Access Compliance Report

Public Rights-of-Way

Intersection ID: 49656	Main Street: SKYLINE_VIEW_WY	Cross Street: SEIGLE_POINT_DR	Location: SW
ADA ID: A907A828E468	Ramp Type: Directional1	Initial Pass/Fail: Pass	Overall Compliance: No
		Severity Score: 5

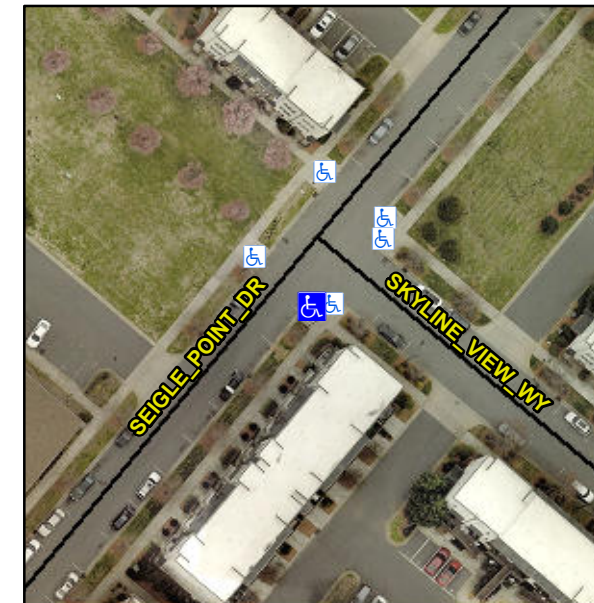
R304.5.3, R302.7, R304.5.4

**Remove & Replace Landing.
Remove & Replace Gutter.**
